A study on the feasibility of measures relating to the protection of pedestrians and other vulnerable road users – Addendum to final report

EC Contract No. ETD/FIF.20040644

Version: Final

**Client: European Commission, Enterprise Directorate-General,
Automotive Industry**

Figure 3.1. Number of cases in BAS database by mean braking deceleration

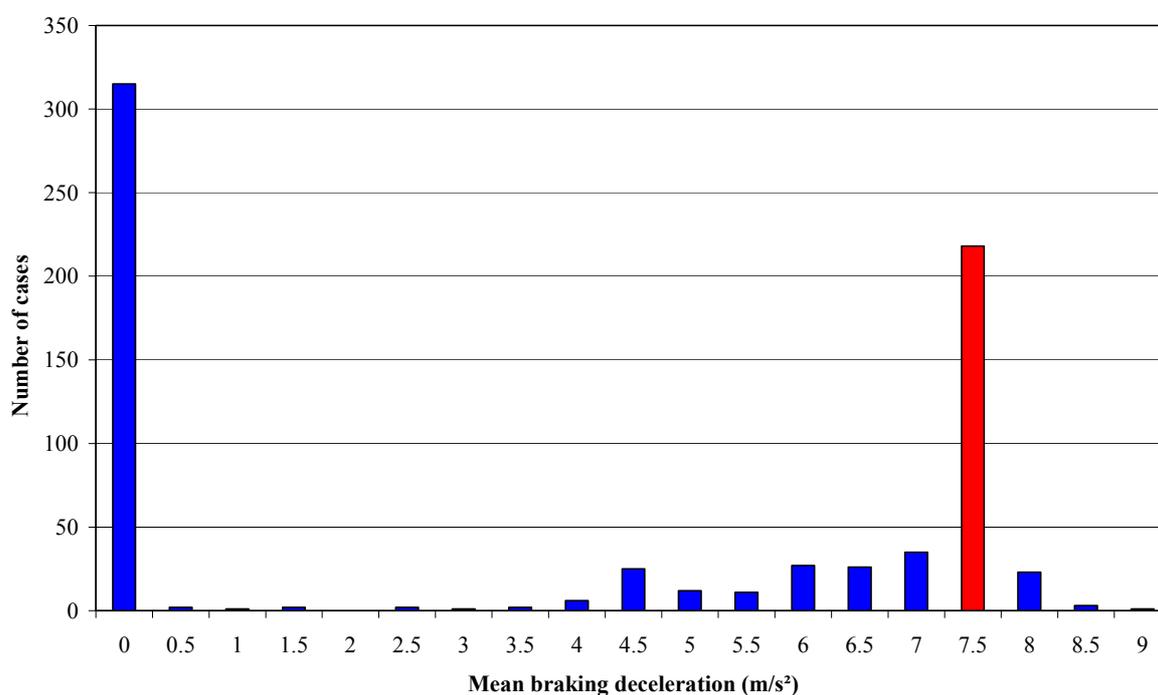
One method that might be used to estimate the benefit of harder braking is to compare the length of pre-impact tyre marks with estimates of the speed and coefficient of friction. If TRL's opinion on tyre marks is accepted then this would be a spurious calculation, as braking would have had to be close to the maximum to have left marks. However, if tyre marks from low braking decelerations can be identified then this method can be used, provided the estimates of travelling speed, impact speed, pre-impact braking distance and road surface coefficient of friction were all accurate. TRL asked TUD how the coefficient of friction was estimated for each accident. This was particularly pertinent because the distribution in the TUD accident database was not of the form expected (some form of roughly normal distribution would be expected, with a large peak at zero from the no braking cases); see Figure 3.1 for the TUD distribution.

The first TRL question on this point was: *“If the decelerations achieved were in many cases limited by the driver's applied pedal force then why did so many drivers achieve 7.5 m/s² (compared with 7.0, 8.0 m/s², etc)?”* (as shown in Figure 3.1).

The second TRL question was: “*Is there something about the reconstruction method that keeps giving this value, in which case how reliable are the braking deceleration values produced?*”

ACEA / TUD's answer was: "The values in the database are average values and depend on the results in the investigation on the spot. They vary because e.g. the traces aren't homogeneous over the length. The BAS benefit consists of a constant high deceleration, a

better usage of the friction coefficient and of the compensation of insufficient driver pedal application.”

ACEA / TUD’s answer was: “The values used in the accident reconstruction are based on experience of the expert. The braking decelerations in the recalculation are based on objective tests with BAS equipped cars (significantly reduced due to the conservative approach).”
